D.A. Boatshed & Slipway

129 Riverview Road, Avalon

Report to Development Unit, 2 7 MAR 1986

DEVELOPMENT APPLICATION (No. 1985/661) (Lodged 11.11.85, amended 20.12.85)

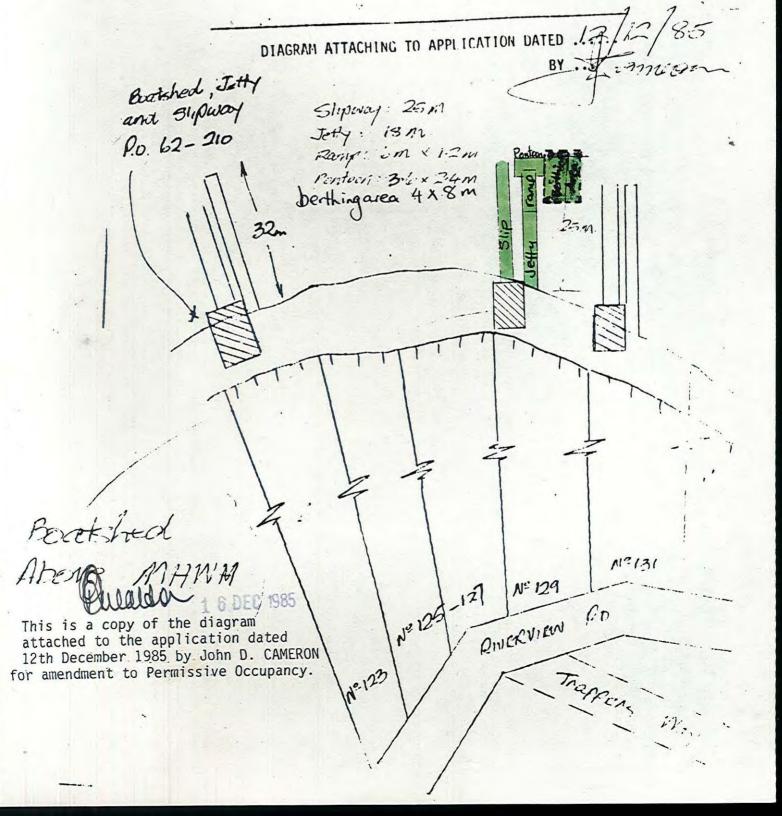
Please delete the boatshed from the above application and add pontoon, ramp, jetty and bertherea, as per attached plan. The boatshed has been relocated entirely above MHWM and is currently subject to a building application.
